Asheville Bicycle and Pedestrian Task Force
Minutes
June 15, 2017

Speaker/Presentation: Bruce Emory, Multimodal Transportation C Chair, and Ken Putnam, City Transportation Director, presented NCDOT proposal designs for the I-26 Connector at Amboy Road and Haywood Road.

Comments on I-26 Connector Design Options
Janet Barlow

Amboy Road/Brevard Road: Split Diamond Concept

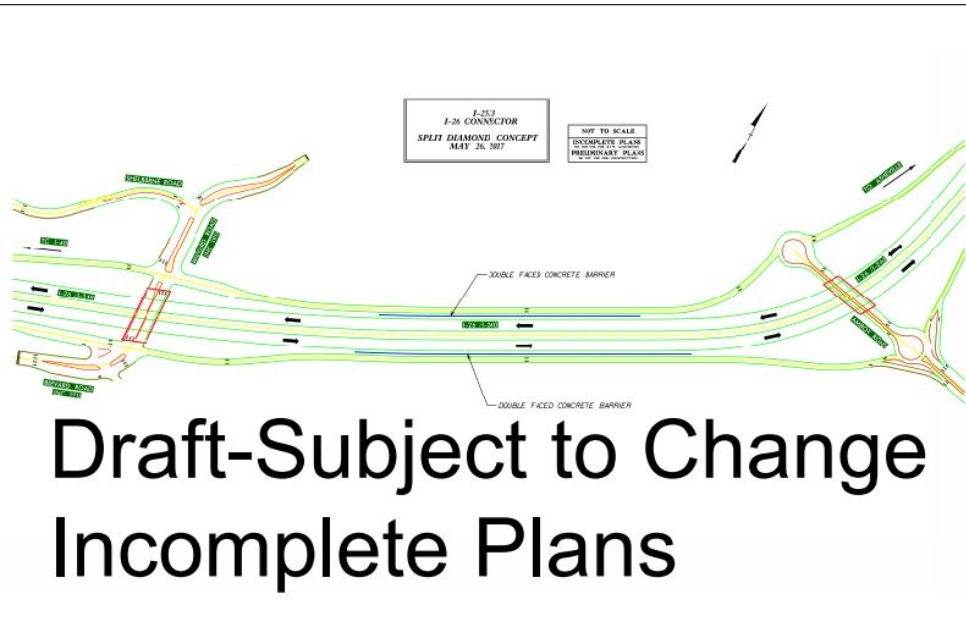
Name:(Optional)	Comments:
Ken Putnam	Provide separate bike and pedestrian facility to connect Amboy Road and Brevard Road.
Billie Lofland	Separate multi-use facility should have pedestrians separated from cyclists by signage and markings. I experience and have people tell me of sometimes adversarial conflicts on greenways, with peds taking up the whole space, or cyclists not giving way to peds. Concerns on how pedestrians will safely maneuver the roundabout connected to Amboy Road. Roundabout can add distance to walking routes which can cause problems when there is bad weather. If separate bike/ped facility cannot be funded, the roundabouts need to be designed for slow vehicle speed and offer maximum protection for cyclists and pedestrians.
Barb's meeting notes	What is the grade of the proposed roadway route? Very important to many bicyclists.
Barb's meeting notes	Slowing down the traffic is important - adjacent to neighborhoods, entrance to Carrier Park area

Barb's meeting notes	Connect pedestrian and bicycle paths to the neighborhood streets even if no motor vehicle connection
Barb's meeting notes	Must make this as inviting and safe as possible for bicyclists and pedestrians

Barb's meeting notes	Brevard Rd intersection is important - the details will be vital to making it work for peds/bikes
Barb's meeting notes	Is there an option for a separate facility, especially approaching and between the roundabouts? Maybe below?
Barb Mee (personal note)	Though I think the proposal includes a pedestrian path, when there is much of a grade to climb an adjacent pedestrian way, sidewalk, mixed use path, etc., can become important. If I suspect I may not be able to make the full hill on my bike, I want to have an easy-to-access place to go when I move from riding to walking my bike up the hill.
Han Winogrand	Provide a separate, protected bike and pedestrian path on proposed north arterial road of sufficient width to accommodate both users.
Han Winogrand	On south side of new arterial road provide a protected bike/pedestrian path to connect to French Broad Greenway.
Han Winogrand	From Fairfax Ave, East of Brevard Rd, build infrastructure to allow pedestrians and cyclists access to new bike/ped path.

Han Winogrand	At Amboy Rd proposed roundabout include bicycle and pedestrian only access from Virginia Ave, reconnecting the neighborhood to the river.
Han Winogrand	At Amboy and I-26 design roundabout to require safe speeds, possibly including: smaller radius, narrow road width, wide, raised crosswalks. Build roundabouts with a single lane. Chapter 5 of the U.S. DOT FHWA publication, "Roundabouts: An Informational Guide," states that adding an additional lane to a one-lane roundabout is likely to increase overall injury crashes by 25 percent.
Han Winogrand	At Amboy circle install a bike lane or "bicycle use full lane" signage for circle and bridge.
Han Winogrand	Remove the extra cut through lanes outside of the Amboy traffic circle to increase safety for all users.
Han Winogrand	At Brevard Rd and I-26 design for one lane in each direction with wide, raised crosswalks and designated, protected bike lanes. Bridge wide enough to accommodate all users.

Han Winogrand	"No right turn on red" signage at all junctures to keep crosswalks safe and unobstructed and to simplify traffic patterns for all users.

We need to think of this project as a part of the bigger plan to make a network of bicycle/pedestrian facilities that encourage and accommodate active transportation. As such, we need to slow down motor vehicle traffic to levels that encourage safe interaction with bicycles and pedestrians at conflict points. With this in mind, separated facilities at conflict points such as crossing I-26 are most desirable. If separate facilities are not feasible, then we need to slow down traffic and give PRIORITY to non-motorized traffic at conflict points.

Haywood Road: Tight Diamond Concept

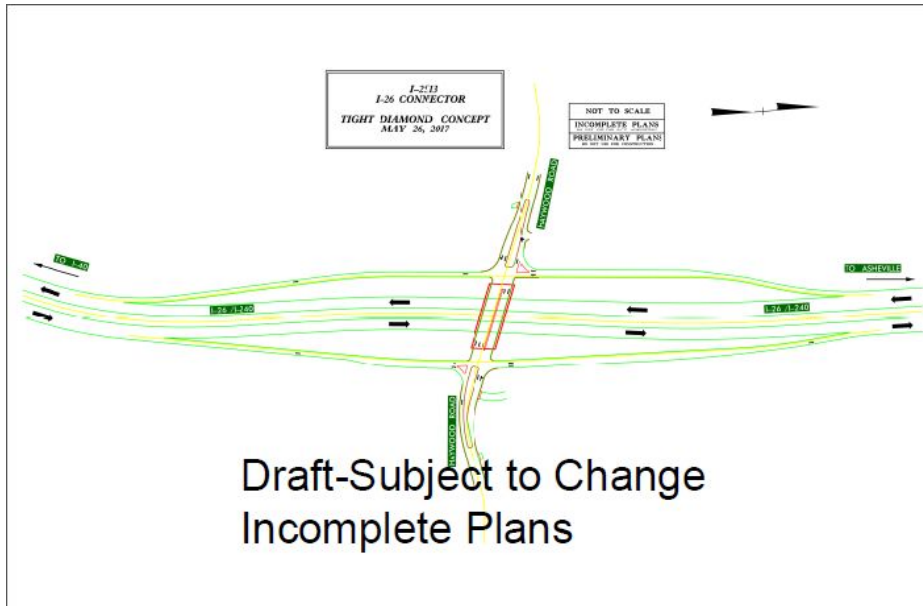
Name:(Optional)	Comments:
Billie Lofland	The group seemed to think that the “Median U-Turn” concept is preferable. As currently drawn, this option provides less conflicts for pedestrians. At each ramp, the pedestrian has to deal with only one or two lanes of cars. This design provides a median between the right-turn and straight/left lanes for pedestrian safety. It seems the “Modified U” would cost quite a bit more money with the construction of two extra bridges. Perhaps the “Tight Diamond” design could be revised to provide separate multi-use lanes on both sides of the bridges.
Barb's meeting notes	Note about plans: Though AIM and bike plan recommend sharrows for much of Haywood Rd, they did not contemplate the changes being made with I-26. Sharrows are not the best/not an adequate treatment across the overpass, and unprotected bike lanes put bike/ped in fear of/at risk of being sent over the side.

Han Winogron	Prefer this “Tight Diamond” or “Median U-Turn” concepts.
Han Winogron	Include design elements to help motorists make the transition from highway to slow, pedestrian and bicycle friendly, community street. Signage, rumble strips on approach ramps, raised crosswalks.
Han Winogron	Include “No right turn on Red” signage to keep crosswalks safe and unobstructed by vehicles coming from highway.
Han Winogron	Painted bike lane through intersection and across bridge.
Han Winogron	Wide sidewalk across bridge.

<p>Raised, wide crosswalks at all crossings.</p>
<p>Han Winogrand</p>	<p>Vehicle stop lines placed a generous distance behind crosswalks to discourage vehicles from blocking pedestrians.</p>
<p>Han Winogrand</p>	<p>NACTO bicycle boxes at stop lights on each side of bridge. Box for Haywood westbound will allow cyclists to safely integrate with vehicles as the lane becomes too narrow to share.</p> <p>https://nacto.org/publication/urban-bikeway-design-guide/intersection-treatments/</p>  <p>bike-boxes/xcv</p>
<p>Han Winogrand</p>	<p>Eliminate islands and cut through lanes on north east and south west corners. Merging vehicles from highway a safety issue for pedestrians, cyclists and vehicles on Haywood Rd.</p>
<p>Linda Giltz</p>	<p>Important to provide bike lanes approaching the bridge and on the bridge. There are currently no bike lanes near the bridge. (this comment applies to all alternatives)</p>

<p>Linda Giltz</p>	<p>Higher railings needed by the sidewalks along the edges of the bridge. (this comment applies to all alternatives)</p>

Haywood Road: Median U-Turn Concept

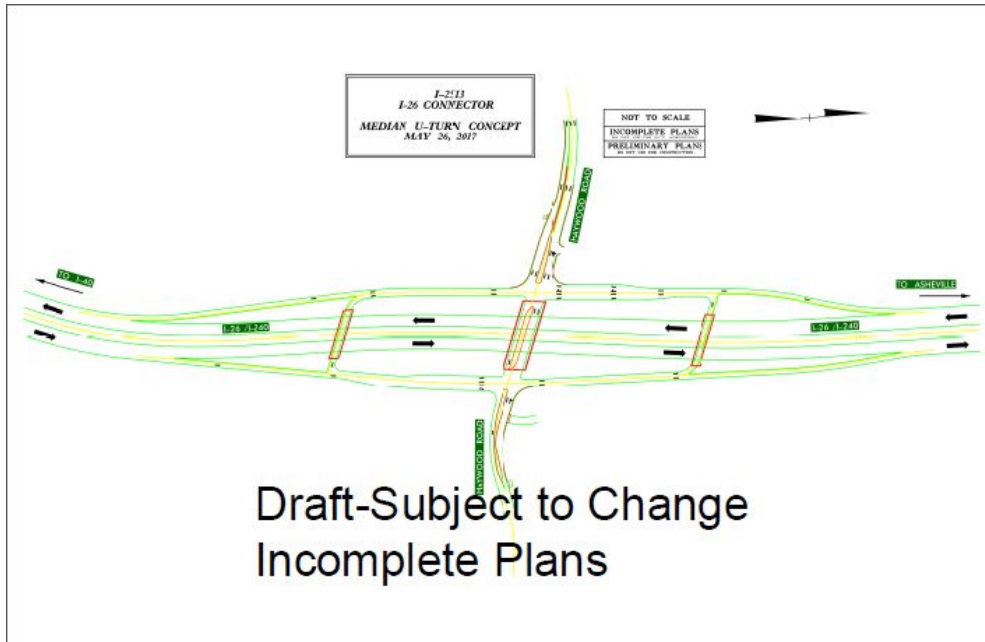
Name:(Optional)	Comments:
Ken Putnam	More bike and pedestrian friendly than other options.
Billie Lofland	As I am interpreting this conceptual plan, drivers from southbound and northbound I-26 exits will be able to go in all directions--right, left and straight. In the meeting it was said there may not be all those lanes, but if there are, it will be very difficult for pedestrians. Two lanes may stop, the driver in the right lane may take a quick look, miss seeing the pedestrian and continue on. In the "Tight Diamond" design There is no island for the pedestrian to separate the right turn lane from the straight/left turn lane. It seems the "Modified U" would cost quite a bit more money with the construction of two extra bridges. Perhaps the "Tight Diamond" design could be revised to provide separate multi-use lanes on both sides of the bridges.
Barb's meeting notes	Option 1 that re-routes left turns via new bridges is most appealing of the choices, but not perfect.

Barb's meeting notes	Option 1 has pedestrians crossing four lanes of traffic at bridge ends, and some of that traffic will have come directly from the interstate. Would be best to have fewer conflict points, but will definitely need ped safety focus in design and operations
Barb's meeting notes	Option 1 appears to have potential for two-way cycle track in center of bridge

Barb's meeting notes	Remember that this connects to a greenway, and therefore you must assume young/elderly, inexperienced, or unsure riders. Making the connection from E-W Avl as comfortable as possible is important.
Barb's meeting notes	Note about plans: Though AIM and bike plan recommend sharrows for much of Haywood Rd, they did not contemplate the changes being made with I-26. Sharrows are not the best/not an adequate treatment across the overpass, and unprotected bike lanes put bike/ped in fear of/at risk of being sent over the side.
Han Winogron	Median U Turn and Tight Diamond are the safest designs for all users. Or roundabout with single lane and traffic calming (see remarks).
Han Winogron	Wide crosswalks and sidewalks, stop lines set back from crosswalks
Han Winogron	Bike lanes across bridge with bike boxes at traffic lights (see comments under Tight Diamond Concept).
Han Winogron	No right turn on red signage to keep crosswalks clear and safe for pedestrians.

Linda Giltz	Important to provide bike lanes approaching the bridge and on the bridge. There are currently no bike lanes near the bridge. (this comment applies to all alternatives)
Linda Giltz	Higher railings needed by the sidewalks along the edges of the bridge. (this comment applies to all alternatives)

Haywood Road: Roundabout Concept

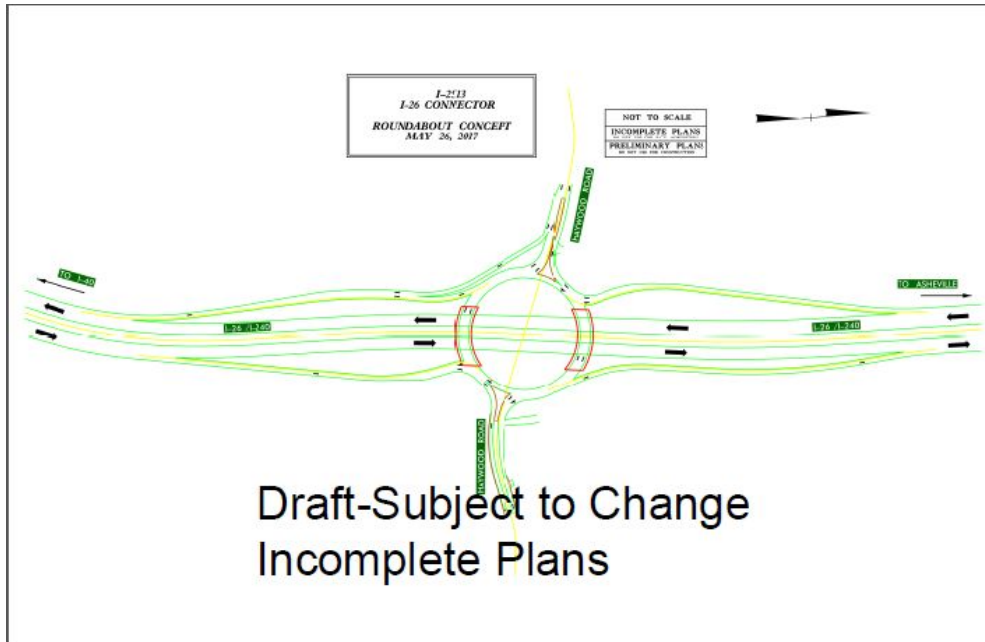
Name:(Optional)	Comments:
Tom Redinger	We didn't discuss this option in detail but, as noted in the meeting, a two-lane roundabout seems to become very similar to the old style "rotary" requiring vehicles to change lanes within the roundabout to either bypass the next off option, and then again to be in the right exit lane when they do wish to exit the roundabout.. This is doubly problematic for the bicyclist in competition with cars during required lane change when the goal is to continue straight through the intersection.
Barb's meeting notes	Options 2 & 3 are not attractive from the pedestrian or cyclist perspective
Barb's meeting notes	Note about plans: Though AIM and bike plan recommend sharrows for much of Haywood Rd, they did not contemplate the changes being made with I-26. Sharrows are not the best/not an adequate treatment across the overpass, and unprotected bike lanes put bike/ped in fear of/at risk of being sent over the side.

Han Winogrand	Roundabout directly from highway onto Haywood may encourage unsafe speeds and endanger cyclists and pedestrians.
Han Winogrand	"Bicycles use full lane" signage through circle to avoid right hooks by vehicles into bicycles.
Han Winogrand	A single lane roundabout with large raised crosswalks, rumblestrips approaching the intersection from the highway and signage "yield to bicycles and pedestrians" would improve safety for all users.

Haywood Road: Ovalabout Concept

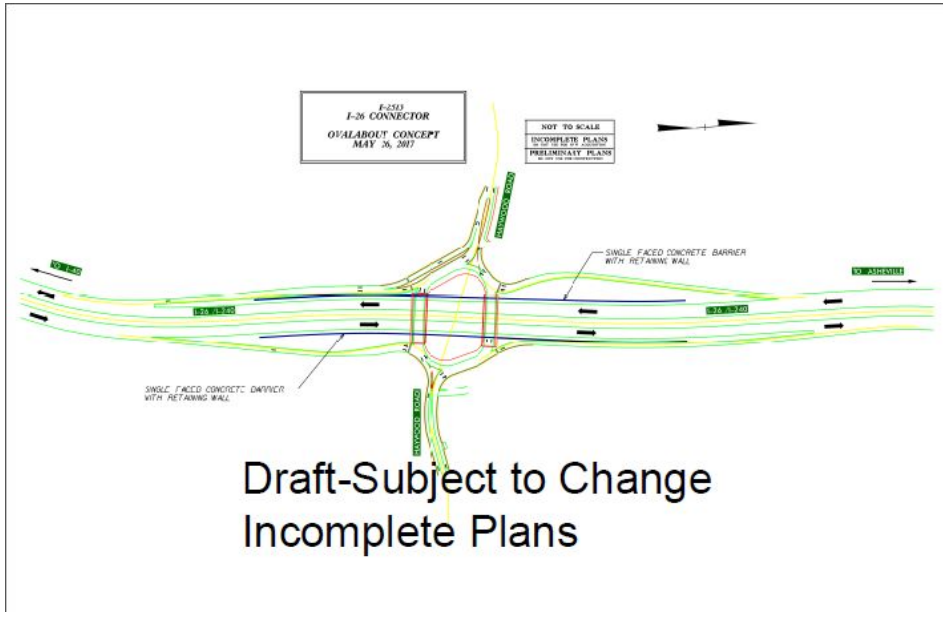
Name:(Optional)	Comments:
Barb's meeting notes	Options 2 & 3 are not attractive from the pedestrian or cyclist perspective
Barb's meeting notes	Note about plans: Though AIM and bike plan recommend sharrows for much of Haywood Rd, they did not contemplate the changes being made with I-26. Sharrows are not the best/not an adequate treatment across the overpass, and unprotected bike lanes put bike/ped in fear of/at risk of being sent over the side.
